TECHNICAL REVIEW AND EVALUATION  
OF THERMAL EFFECTS STUDIES AND  
COOLING WATER INTAKE STRUCTURE  
DEMONSTRATION OF IMPACT FOR THE  
OYSTER CREEK NUCLEAR  
GENERATING STATION

REVISED FINAL REPORT

New Jersey Department of  
Environmental Protection  
Division of Water Resources  
401 E. State Street  
Trenton, NJ 08625

Versar, Inc.  
ESM Operations  
9200 Rumsey Road  
Columbia, MD 21045

Figure IV-1. Location of region used by Versar to estimate ambient temperatures (modified from JCP&L 1978)

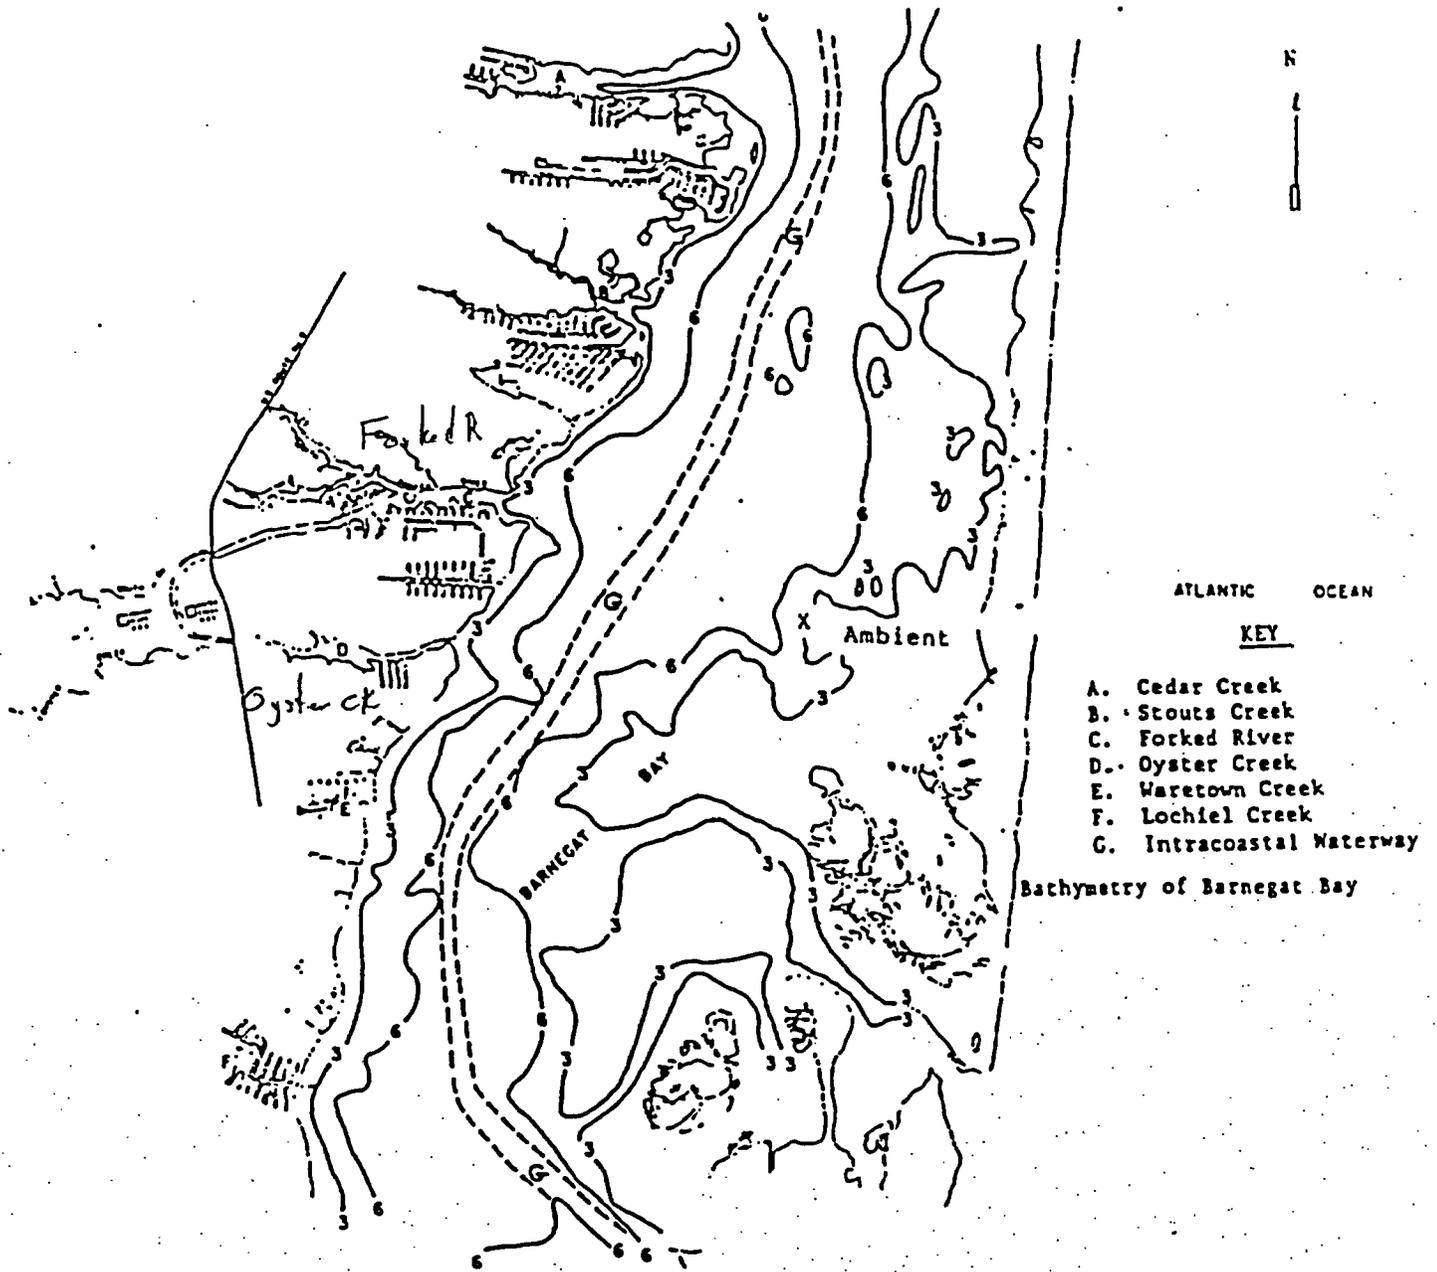
of power production by the Oyster Creek NGS, Newark air temperature, and the southerly wind component. Intake temperature qualitatively tracked air temperature, and based on this finding GPUN concluded that recirculation was small, and that intake temperature was a reasonable estimate of ambient temperature (Figure IV-2). Clearly, this analysis and its interpretation does not reach a reasonable conclusion. A relationship appears to exist between Forked River water temperature, and the interaction of power production of the Oyster Creek NGS and wind condition. Without the raw data used to construct Figure IV-2 this relationship cannot be tested. In addition, this study completely ignored earlier indications of recirculation obtained from the dye studies as well as the thermal plume mapping overflights.

Figure IV-2. Forked River mouth surface temperature and associated environmental data June 24-July 16, 1974 (from JCP&L 1978)

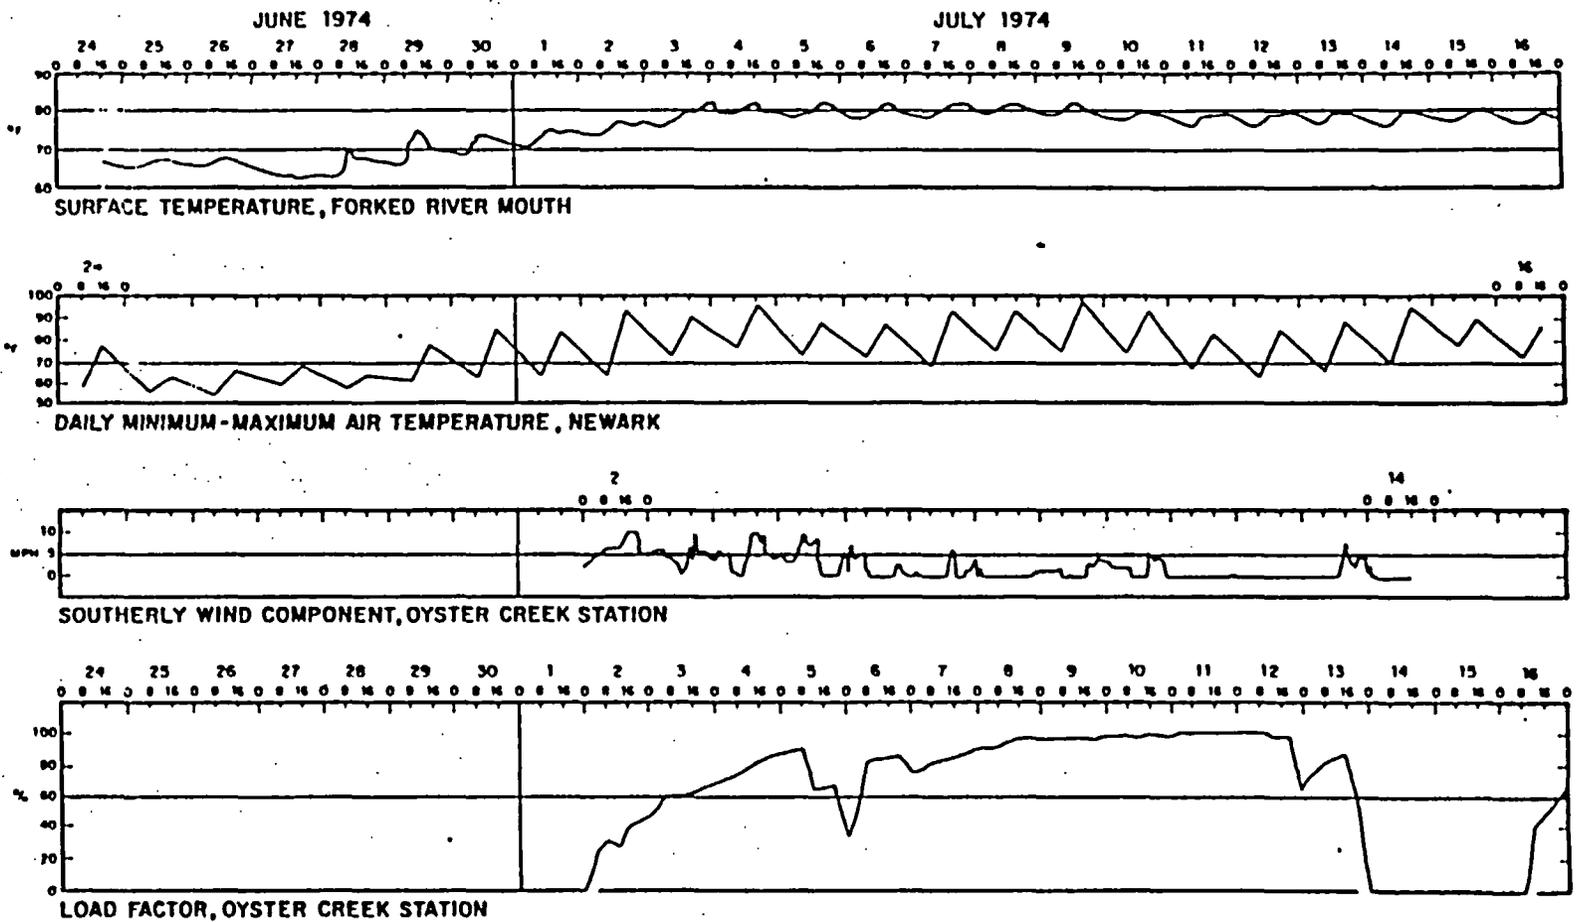
GPUN used a hydrothermal model to assess the compliance of the Oyster Creek's discharge with the thermal regulations. The model was formulated as a two-dimensional steady-state mass and heat balance, and was calibrated to dye and thermal survey data. Early attempts at verification indicated that results predicted by the steady-state model for segments upstream (north) of Oyster Creek were significantly different from observed dye results (Carpenter 1963). No reasonable set of parameters would produce steady-state model agreement with the survey results. Modification of the model to a one-dimensional unsteady-state, constant parameter model produced "adequate" verification. Versar contends that the "adequate" verification is minimal and simply confirms that the steady-state model is a poor reflection of the dynamic conditions characterizing Barnegat Bay. The model was tested under assumed wind/tide conditions. Limited information on model inputs or parameters was presented, and the information provided in the 316 Demonstration documents was inadequate to evaluate the model calibration or validation procedures.
